Proposed Change (218 kV)

SONGS Units 2 and 3

Southern California Edison Company INTERIM CALCULATION CHANGE NOTICE (ICCN)/ CALCULATION CHANGE NOTICE (CCN) COVER PAGE SUMMARY CHANGE <input type="checkbox"/> NO <input checked="" type="checkbox"/> YES	CALC NO. E4C-090		ICCN NO./ PRELIM. CCN NO. C-134	PAGE 1	TOTAL NO. OF PAGES 34
	BASE CALC. REV. 3	UNIT 3	CCN CONVERSION: CCN NO. CCN-		CALC. REV.
CALCULATION SUBJECT: AUXILIARY SYSTEM VOLTAGE REGULATION					
CALCULATION CROSS-INDEX <input checked="" type="checkbox"/> New/Updated Index Included <input type="checkbox"/> Existing Index is Complete	ENGINEERING SYSTEM NUMBER/PRIMARY STATION SYSTEM DESIGNATOR 1804 / PBA			Q-CLASS II	
Site Programs / Procedure Impact? <input checked="" type="checkbox"/> NO <input type="checkbox"/> YES, AR No.	CONTROLLED PROGRAM OR DATABASE ACCORDING TO SO123-XXIV-5.1	PROGRAM/DATABASE NAME(S) <input type="checkbox"/> ALSO, LISTED BELOW		VERSION/RELEASE NO.(S)	
10CFR50.59772.48 Review: AR No. N/A - See PCN 561	<input checked="" type="checkbox"/> PROGRAM <input type="checkbox"/> DATABASE	ETAP		5.0.0N

Specifically, this ICCN defines the design voltage limit at the 4.16kV bus 3A04 based on a postulated switchyard

Page 4 of this ICCN includes the one-line diagram of the analyzed system.

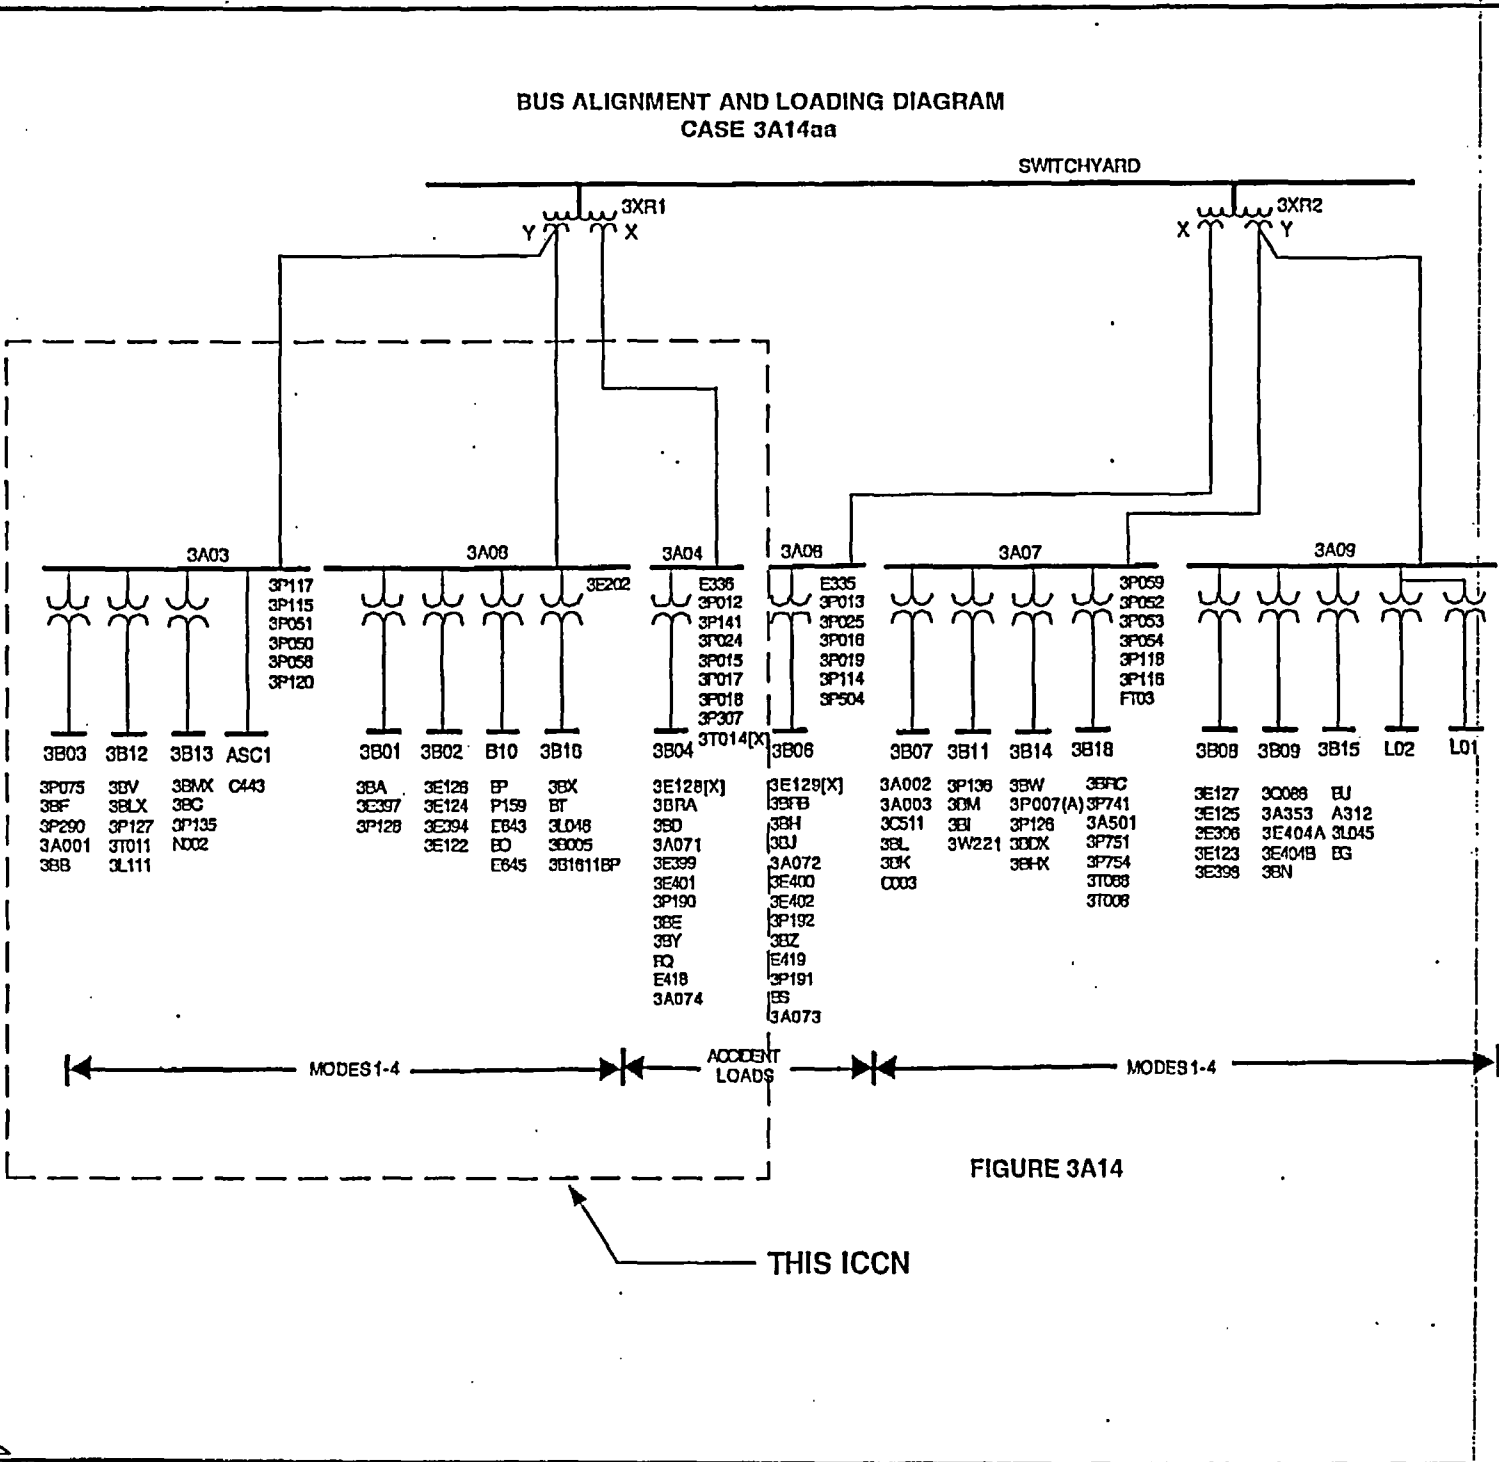
This ICCN includes accident scenario analyses only, similar to base calculation study case 3A14. However, only the affected safety train is analyzed (Unit 3, Train A) to support associated ECP. The included study case is designated as "3A14aa".

This ICCN provides a resultant 4.16kV bus voltage level based on a postulated switchyard voltage of 218kV. The 4.16kV bus voltage will then be utilized for DGV relay maximum reset (pickup) design limit included in calculation E4C-130 Rev. 1, ICCN C-7. This setpoint will then ensure that the 4.16kV bus remains connected to the normal preferred (offsite) power source during the post-accident, post-load-sequencing period.

ETAP load flow is utilized to ascertain the 4.16kV voltage level with a switchyard voltage of 218kV. The report is included in this ICCN on pages 5 through 34.

The resultant 3A04 bus voltage derived in this ICCN is 4161V based on a postulated switchyard voltage of 218kV for the normal preferred (offsite) source.
